TB 173

TECHNICAL BULLETIN

Product : Midilift XL+

Subject : Incorrectly wired mains supply cable

Terminals located in upper landing control panel

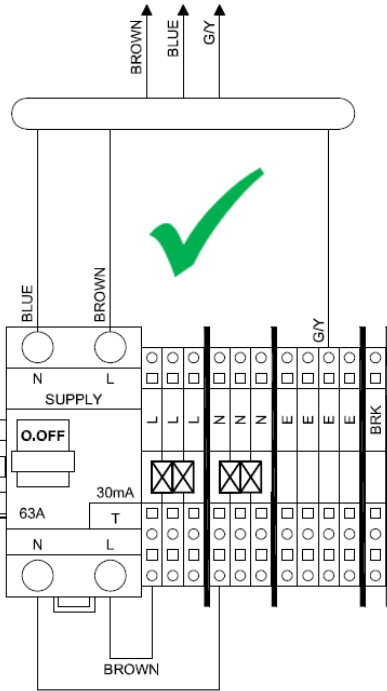
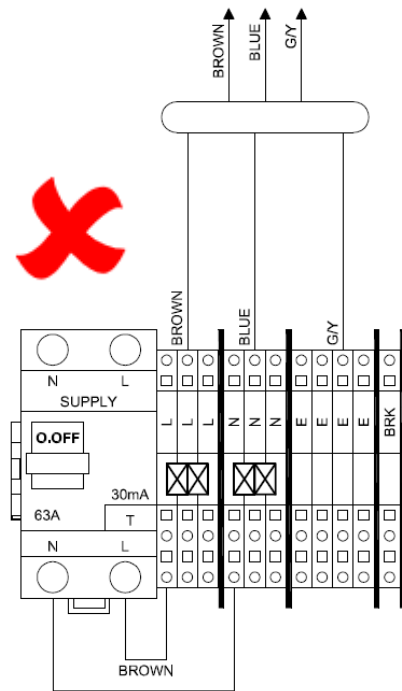
On a recent XL+ installation it was identified that the 230VAC incoming lift supply had been incorrectly wired. This resulted in the lift RCD isolator, located within the upper landing control panel, being bypassed.

On next service visit and during any active installations, all XL+ lifts should be checked to ensure that the mains supply has been connected correctly (see diagram on page 2 for identification).

INCORRECT

1. Turn off and lock off the mains supply to the lift.
2. Confirm mains supply is isolated.
3. Reconnect the mains supply as per wiring manual drawing 9448-24.

CORRECT
